DATE: May 9, 2022  
TO: Potential Respondents  
FROM: Elaine Robbins – Construction Contract Coordinator II  
SUBJECT: Questions #1  
RFP769-22-11315ER  
UNT Frisco Campus Furniture

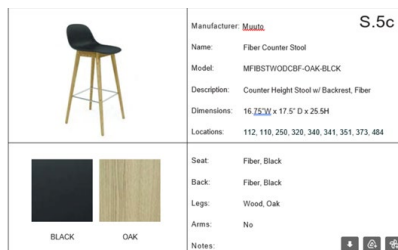
4. We are going to be providing alternates to the workstations. On W.5, the picture is showing a fixed height top with fixed storage underneath. The description is calling for height adjustable table with fixed storage. Should be provide a solution using a height adjustable table, or fixed height table?

**ANSWER: Furniture should be provided as included in the specifications, the adjustable height is correct. The image is included as a reference for finishes and storage below the fixed surface.**
